PLANNING BOARD AGENDA
October 14, 2025 – 6:00 p.m.
City Council Chambers, 60 Court Street

To: Auburn Planning Board
From: David Hediger, Director of Planning
Re: 65 Mount Auburn Avenue: Chick-fil-A Restaurant Update on pedestrian access and site improvements.
Date: October 9, 2025

**RE: Planning Board Site Plan Review – Resubmittal
65 Mount Auburn Ave (Pad Site)
Map 280, Lot 6.1**

C-200

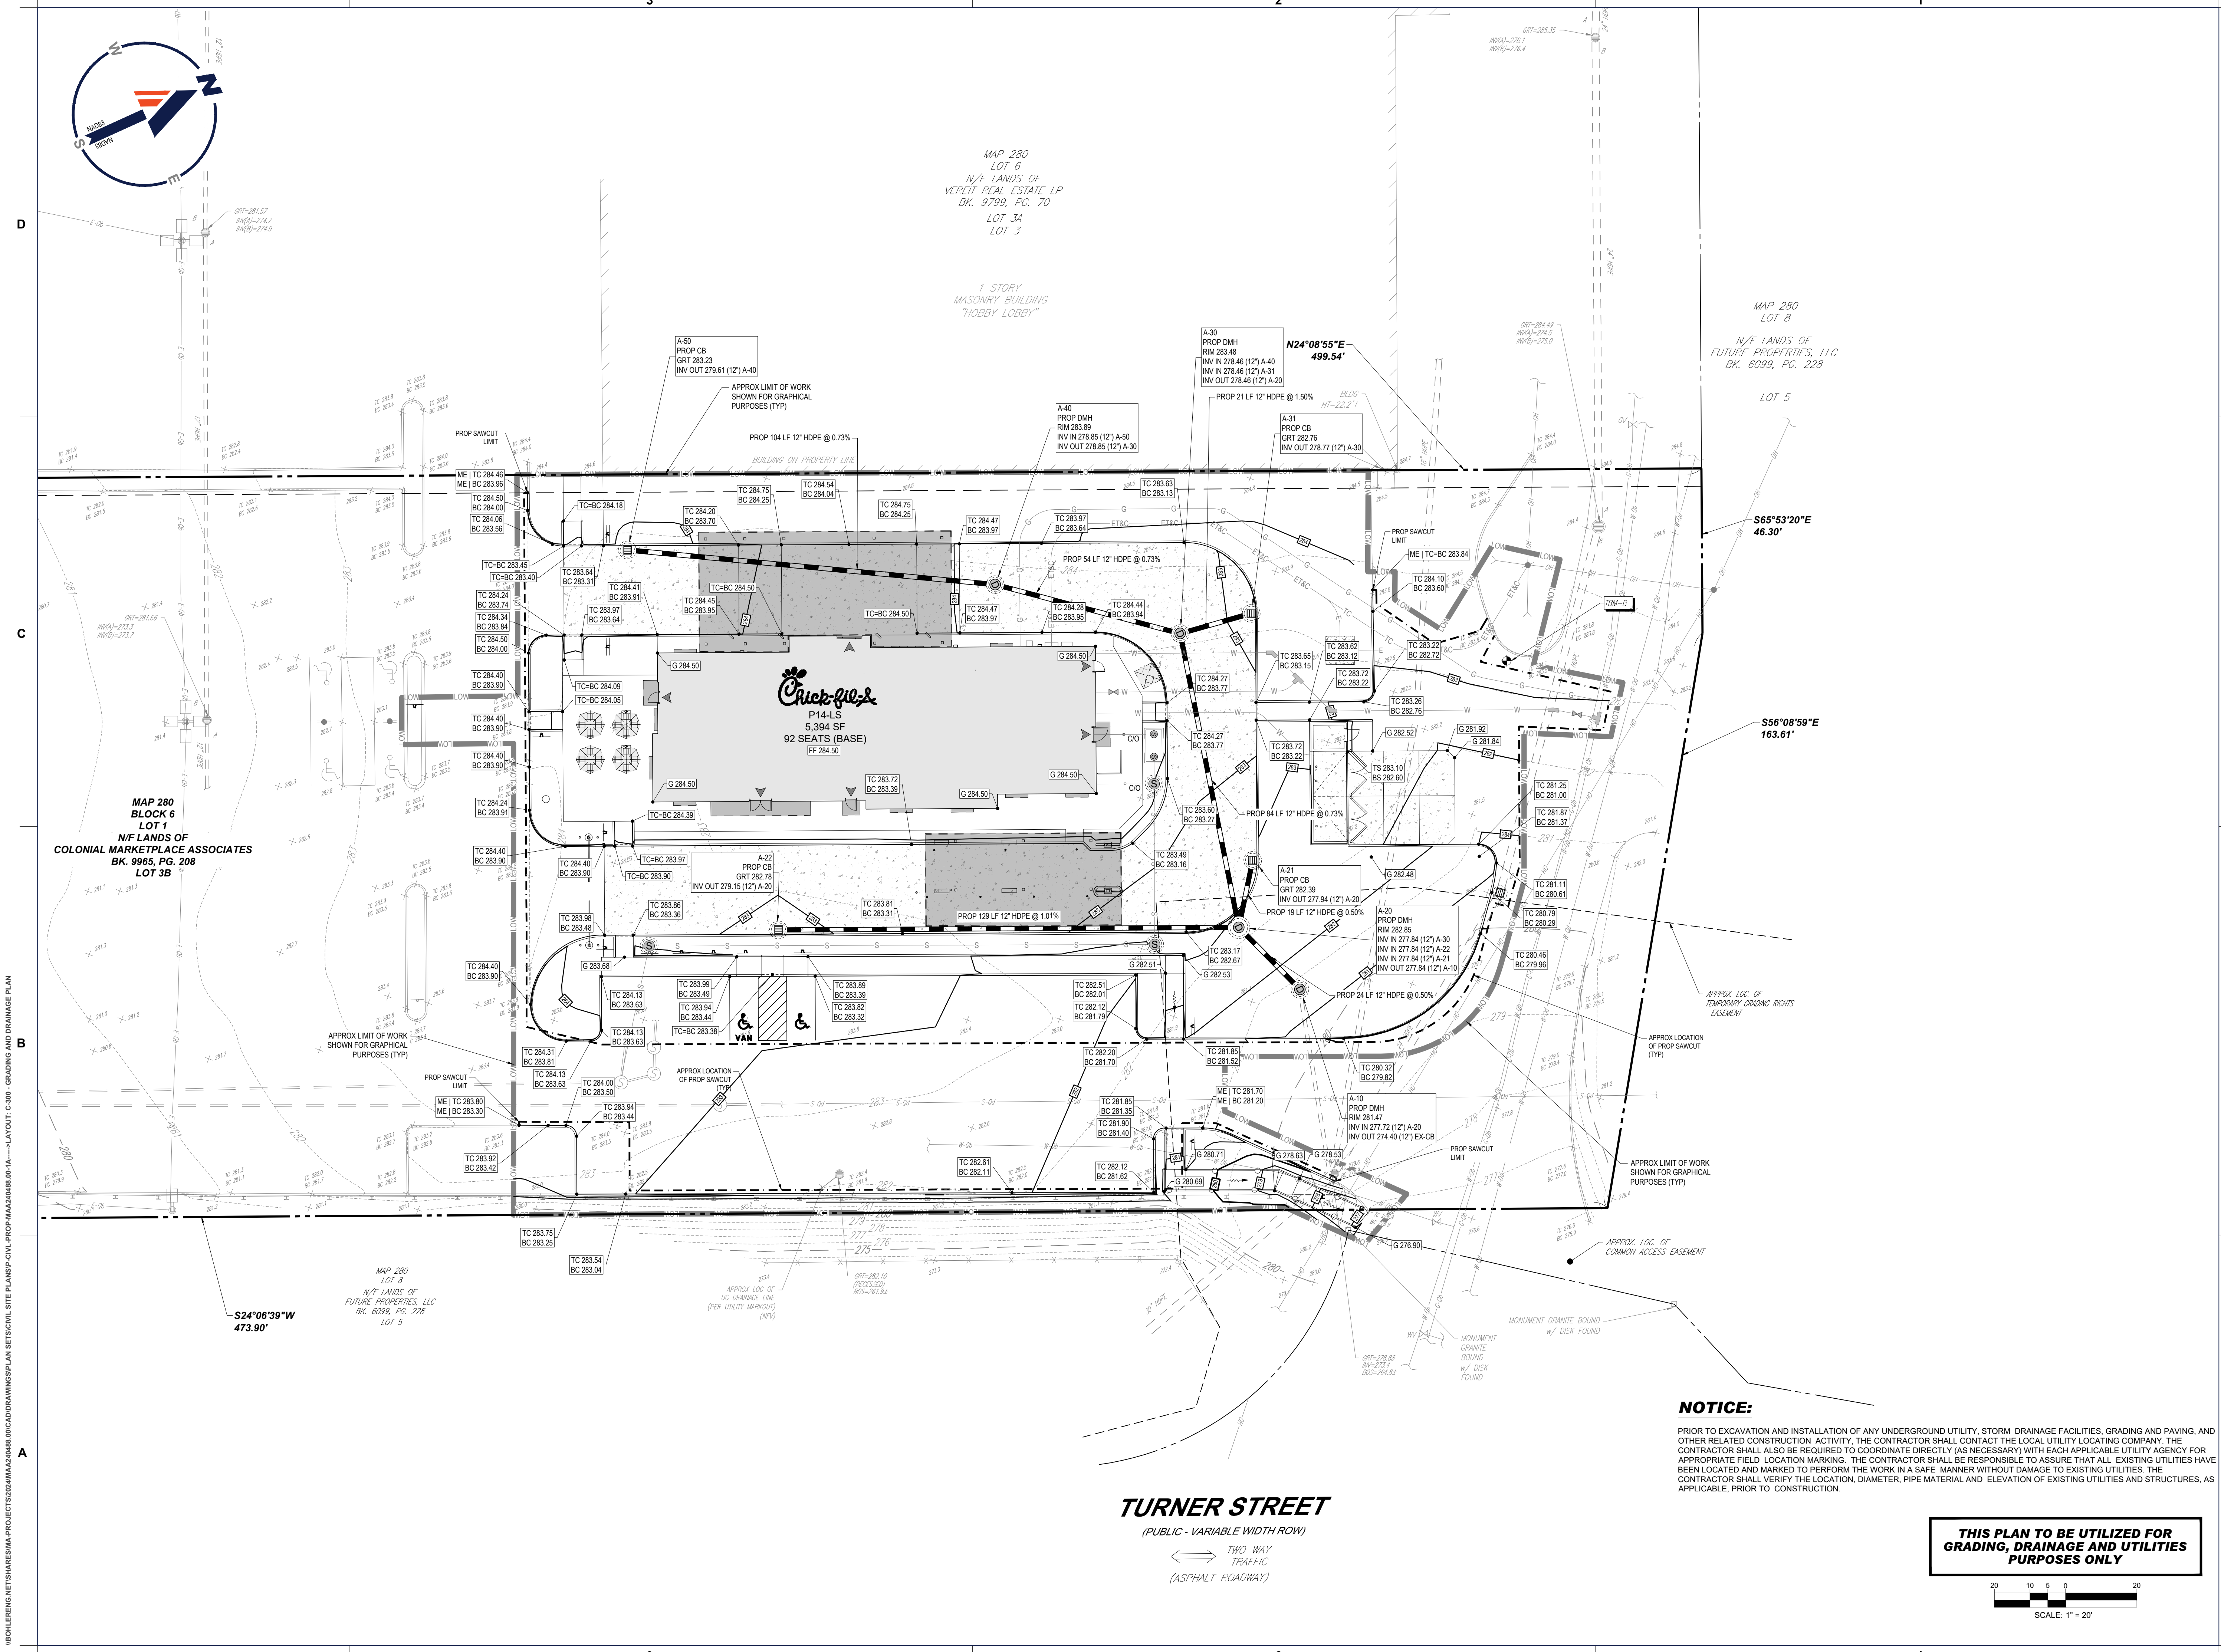
Since that approval, staff have met with project representatives, and the applicant has been working on a revision that provides pedestrian connections to both Turner Street and Hobby Lobby. The revised plan results in the following changes:

- The new restaurant design features a slightly larger building ($\pm 5,394$ sq. ft. vs. $\pm 5,189$ sq. ft.) in a longer layout, now centered on the site with the drive-thru wrapping around it. Indoor seating increases by two, for a total of 92 seats.

- The total drive-thru length increases from ± 790 feet to ± 850 feet, allowing for approximately three additional queued cars.

- The connection to the Hobby Lobby sidewalk remains, and a new accessible ramp and sidewalk connection to Turner Street will be added. This includes landings, handrails, and crosswalks leading safely to the restaurant.

- On-site parking shifts to the south of the drive-thru, with the drive aisle narrowed from 30 feet to 25 feet to promote traffic calming. The new layout adds 16 parking spaces, and Chick-fil-A will also have access to approximately 80 additional spaces in the adjacent parking lot under its lease agreement.

L-101

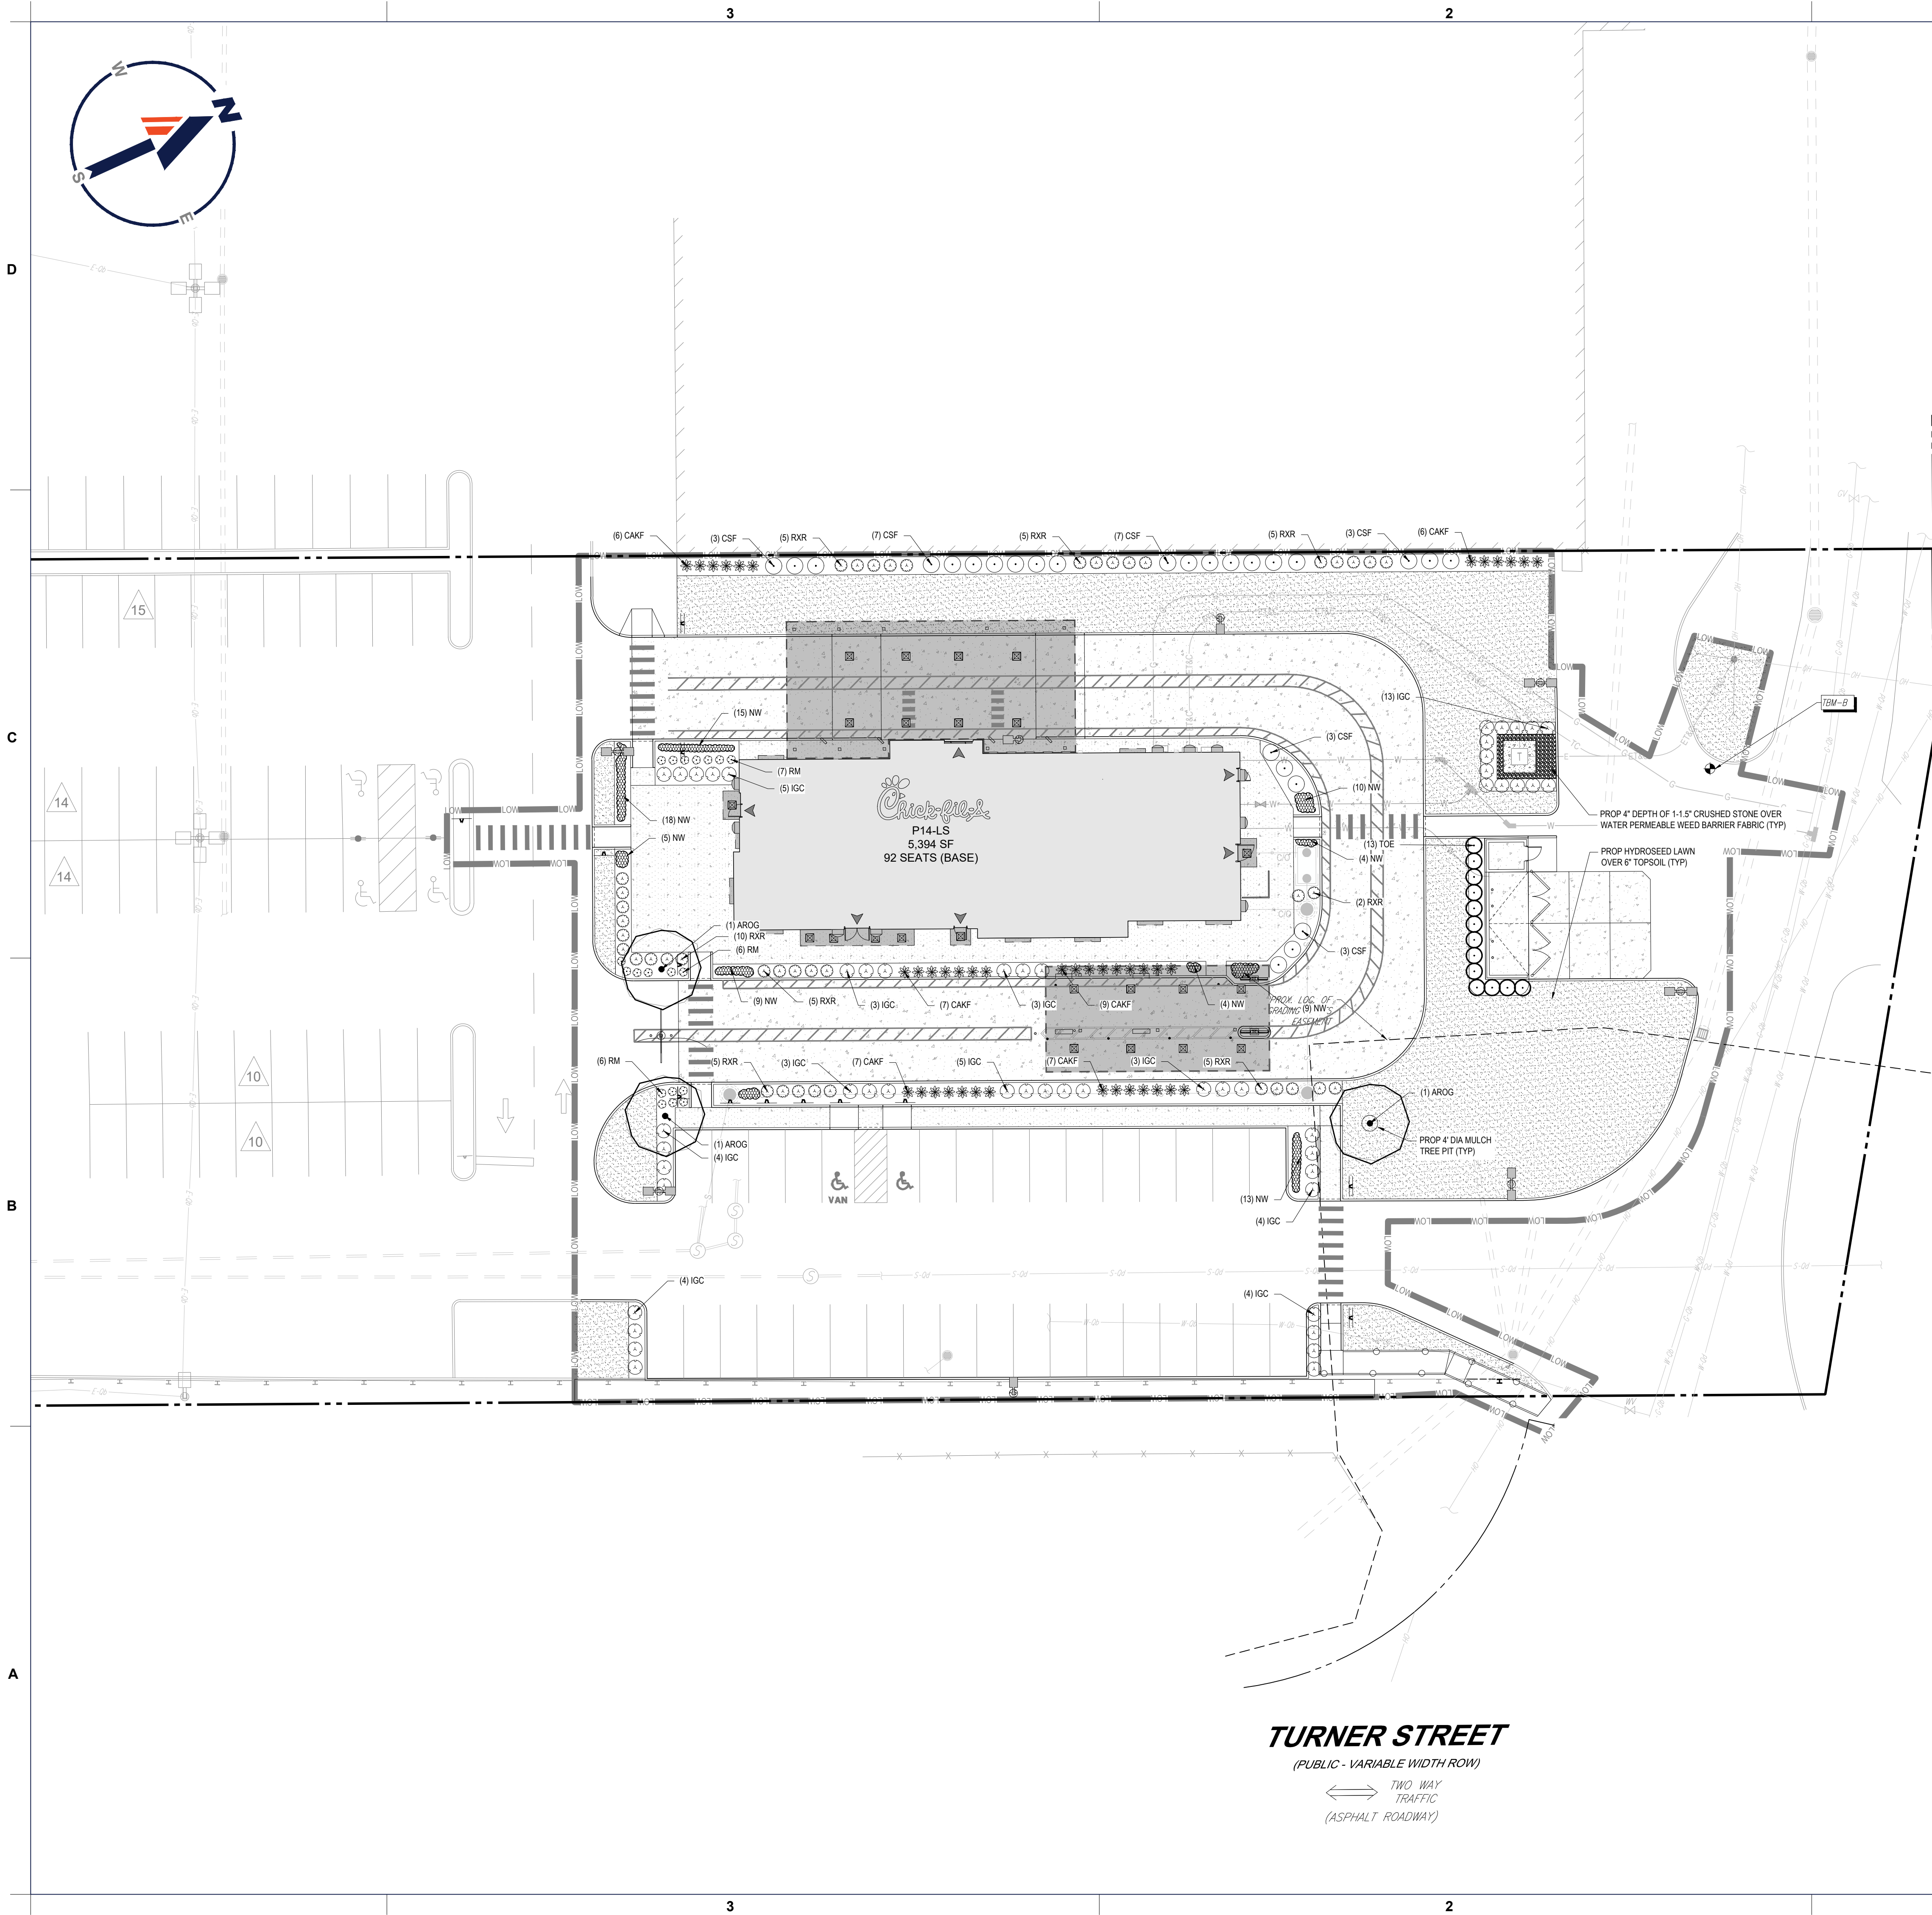
- The reduced impervious area allows for additional landscaping. One fewer light pole will be installed, and updated landscape and lighting plans are included in the revised design.

As noted above, the overall impervious coverage is being reduced which allows for additional landscaping to be provided throughout the project area. The overall site lighting fixture count will be reduced by one (1) light pole. Revised Landscape and lighting plans are also included in this site plan documents.
